**Remedial Investigation and
Feasibility Study Work Plan
Revision 1**

Nevada Environmental Response
Trust Site; Henderson, Nevada

Prepared by:
**ENVIRON International Corporation
Emeryville, California**

Date:
January 10, 2014

Figure
5-2

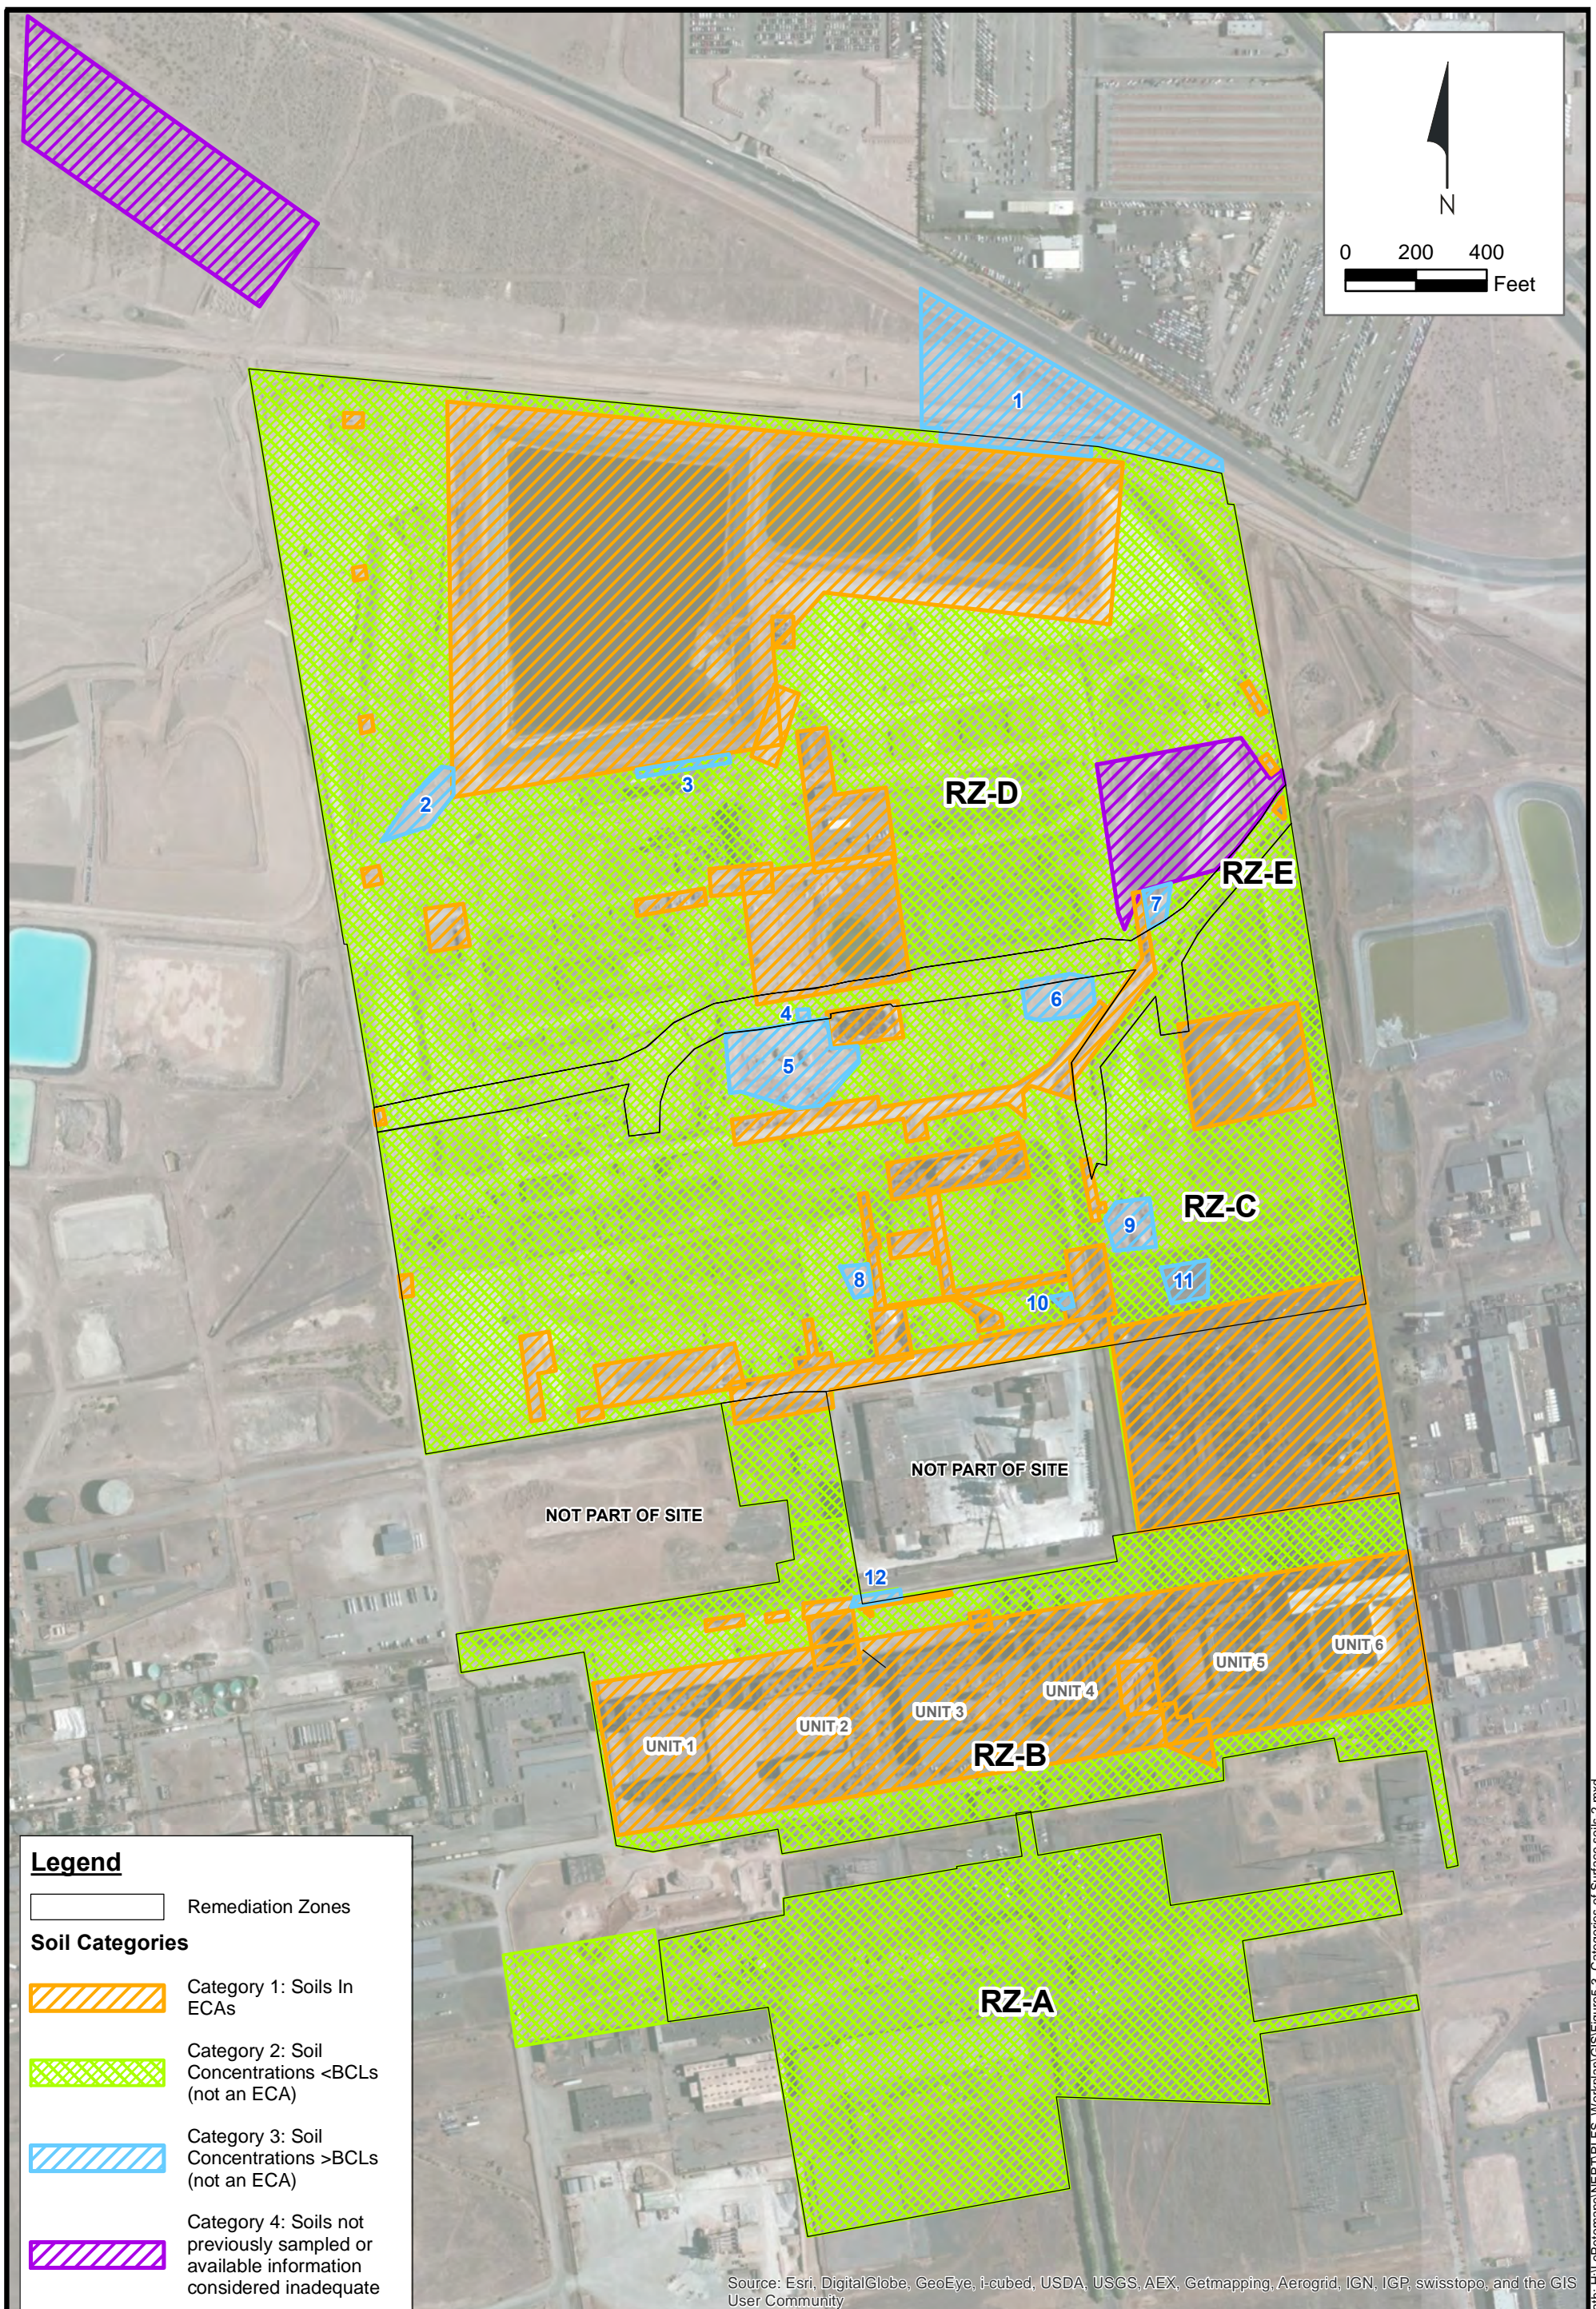
75. Figure 5-2 Historical and Active Pond Locations, the depiction of the Northwest Ditch is inconsistent with what NDEP has seen previously. Please provide a citation for this depiction and discuss with NDEP or revise as necessary.	<p>The depiction of the Northwest Ditch on Figure 5-2 of the RI/FS Work Plan was based on Figure 4-1 of the <i>Phase A Source Area Investigation Results</i> (ENSR 2008a) and Figure 5-2 of the <i>Phase B Source Area Investigation Results, Soil Gas Survey Work Plan</i> (ENSR 2008b).</p> <p>In response to NDEP's comment, ENVIRON reviewed historical reports prepared for the site and other BMI properties. Reports prepared for the TIMET site (Tetra Tech 2005, TIMET 2013) provided additional information on the current locations of the Beta Ditch and Northwest Ditch on the TIMET property as well as the ditch configurations from pre-1955 through 1979. A revised Figure 5-2, incorporating this information, will be provided in the revised RI/FS Work Plan.</p> <p>We note that the locations of the Northwest and Beta Ditches <i>within</i> the site boundary that were shown on Figure 5-2 of the Work Plan are consistent with the ditch locations shown on figures from earlier reports. Thus, ditch locations within the site to be depicted on the revised Figure 5-2 will not change.</p>

5-4

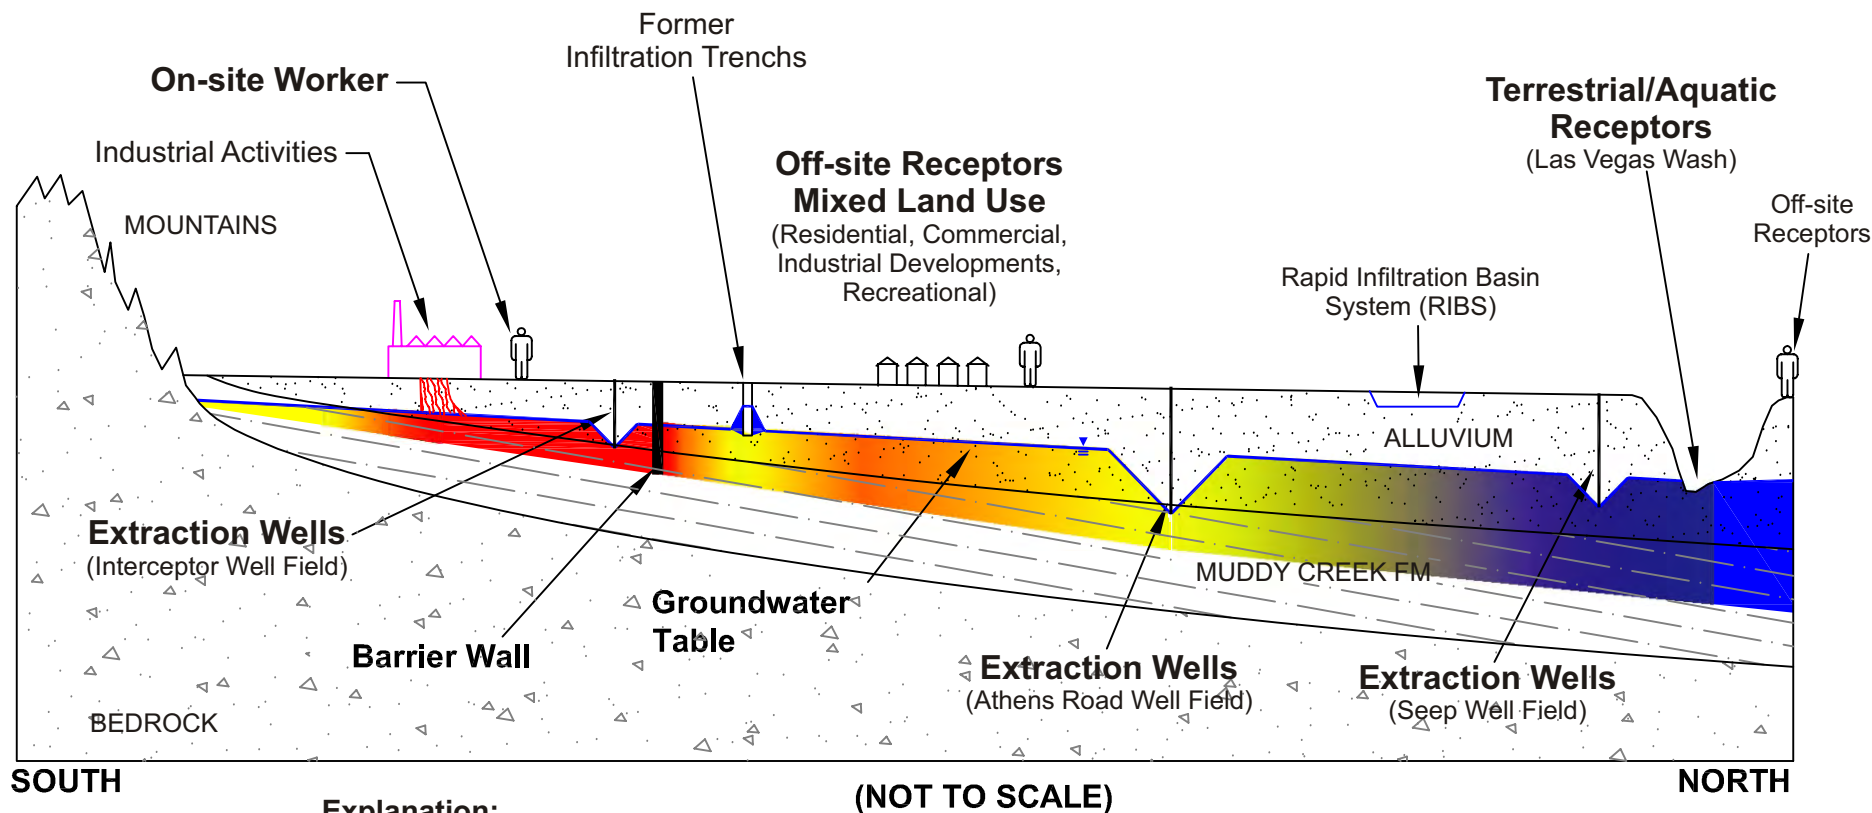
76. Figure 5-4 Preliminary Conceptual Site Model Illustration, please explain the relative impact scale, (e.g., minimal relative to which water quality standard, etc.).	Figure 5-4 will be revised to incorporate the requested change.

Total Chromium in Shallow Groundwater, May-June 2012
 Nevada Environmental Response Trust Site, Henderson, Nevada

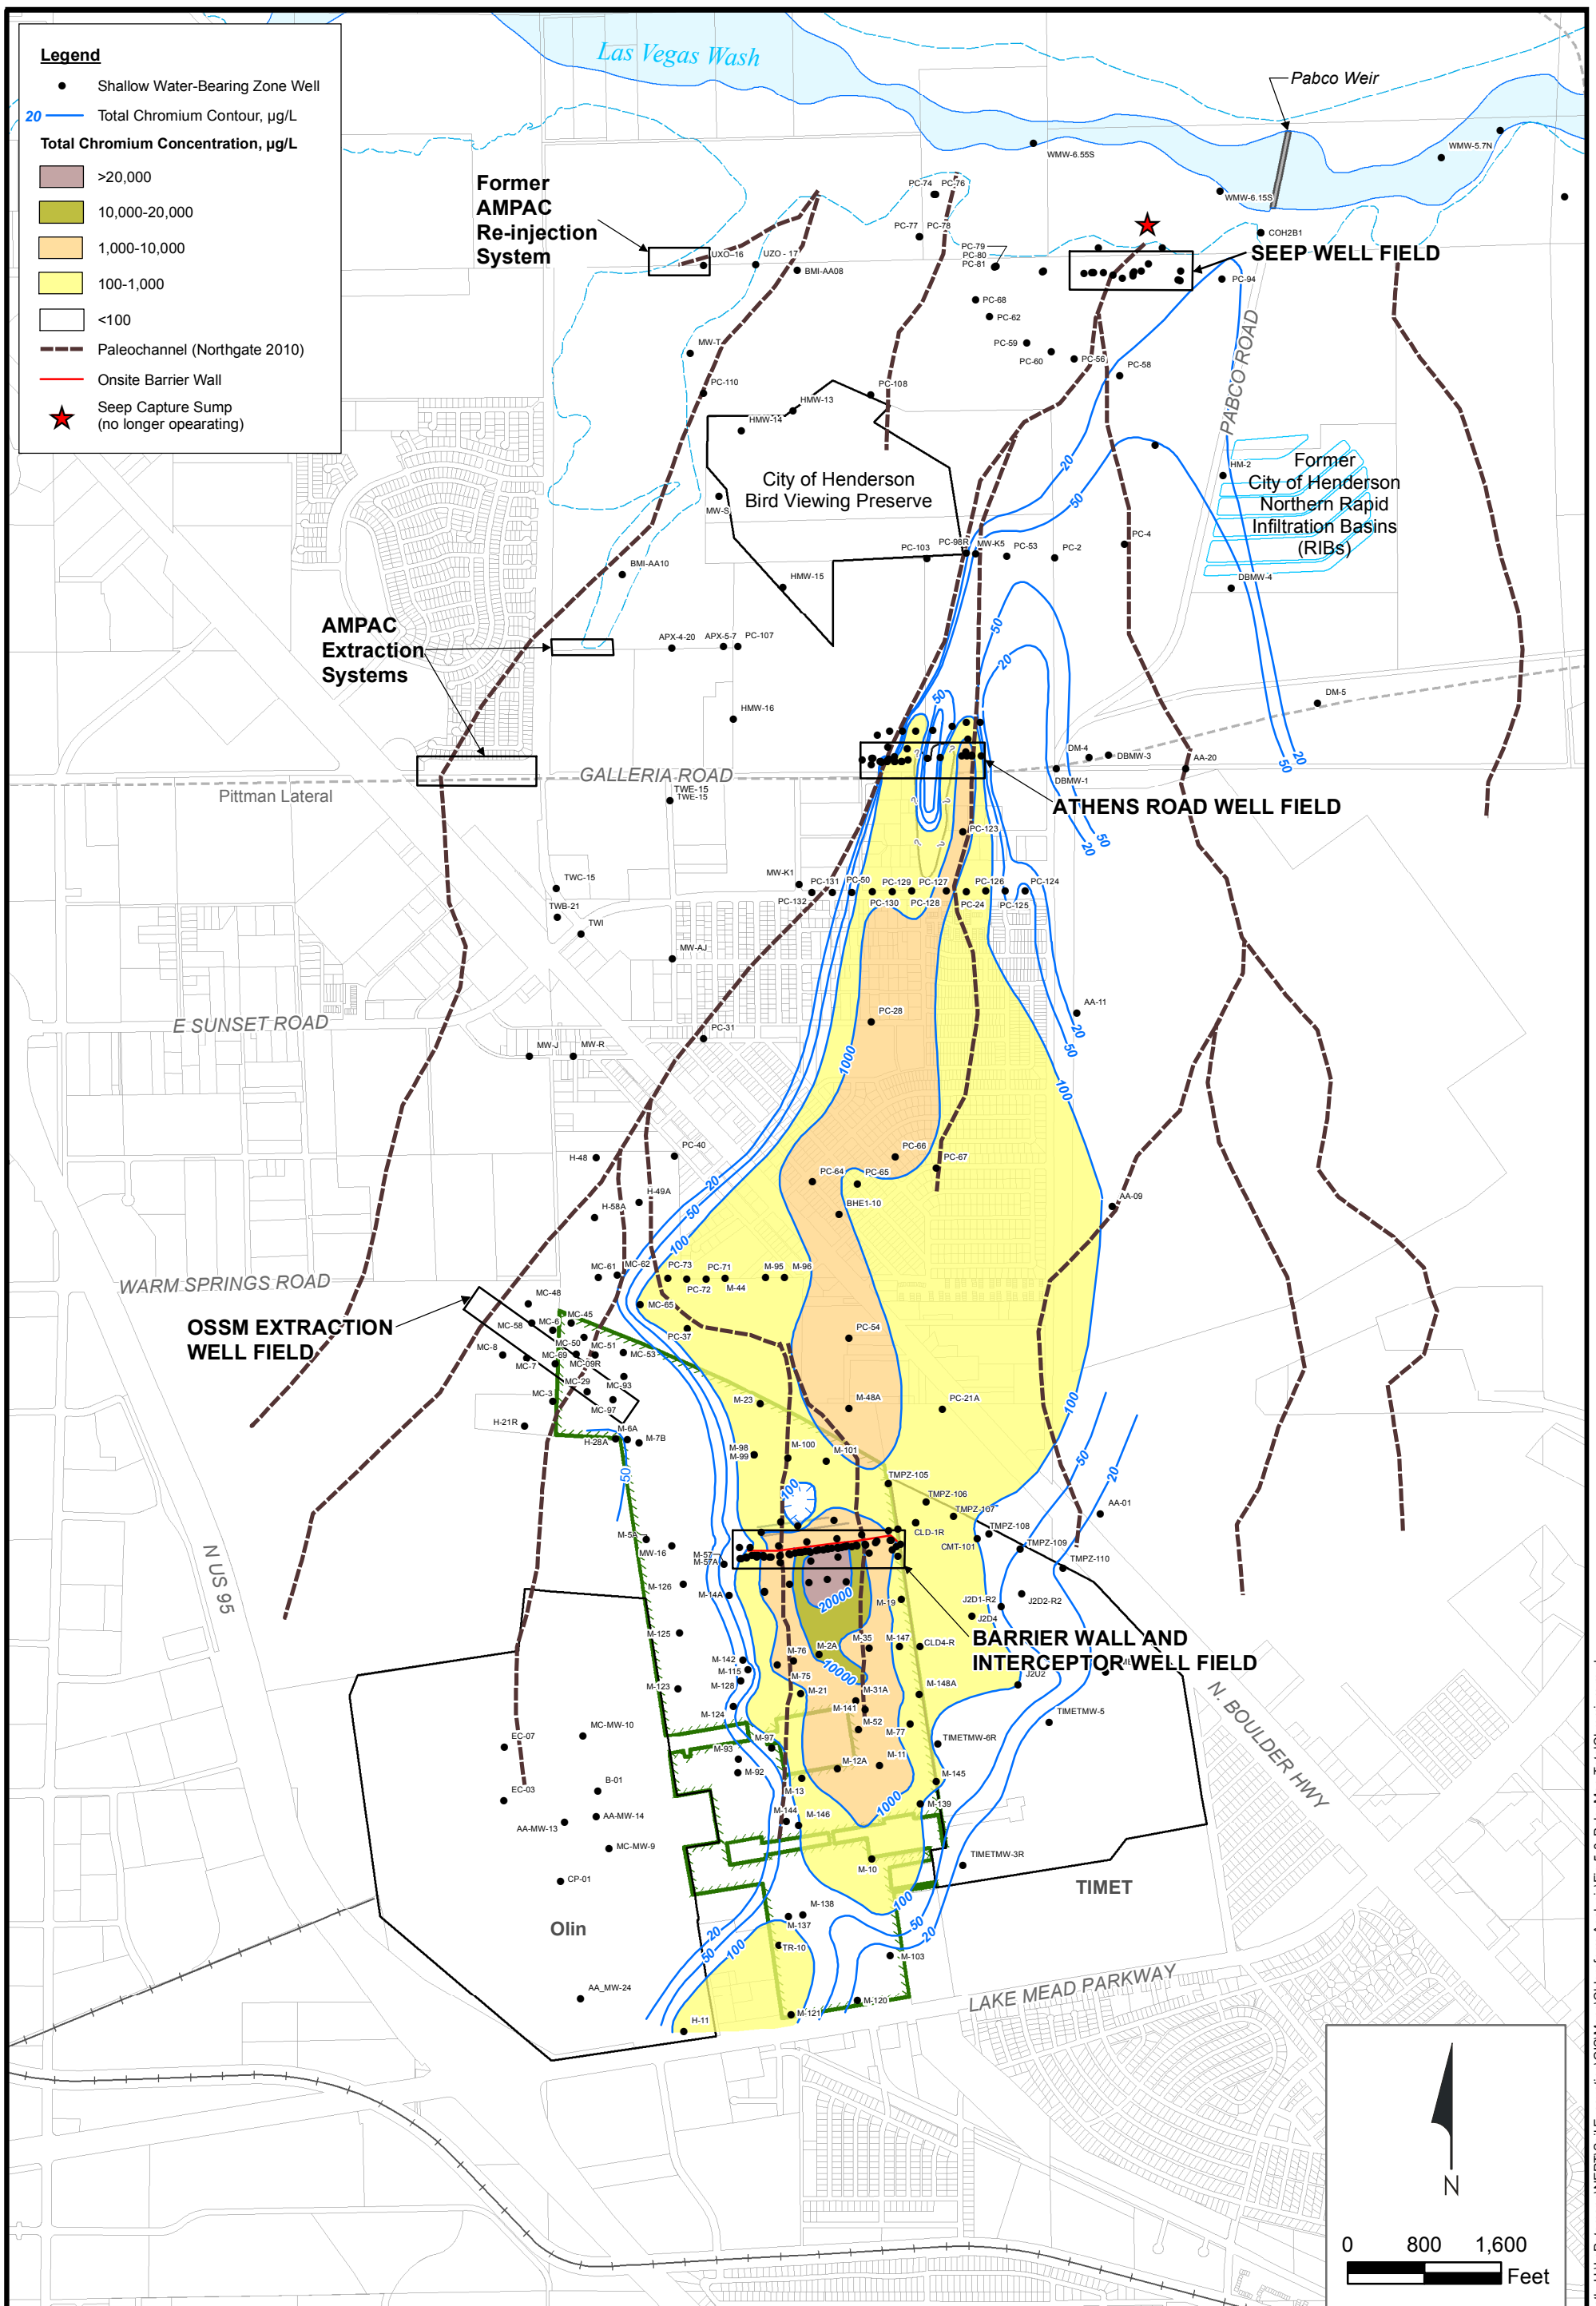
79. Figure 5-8 Total Chromium in Shallow Groundwater, May-June 2012. Greater resolution based on available monitoring data should be provided on the minimum isoconcentration contours.	Greater resolution will be provided on the Plate 4 IWF, AWF, and SWF insets where the well density and the available data are sufficient to allow a more detailed interpretation at the scale of the insets.
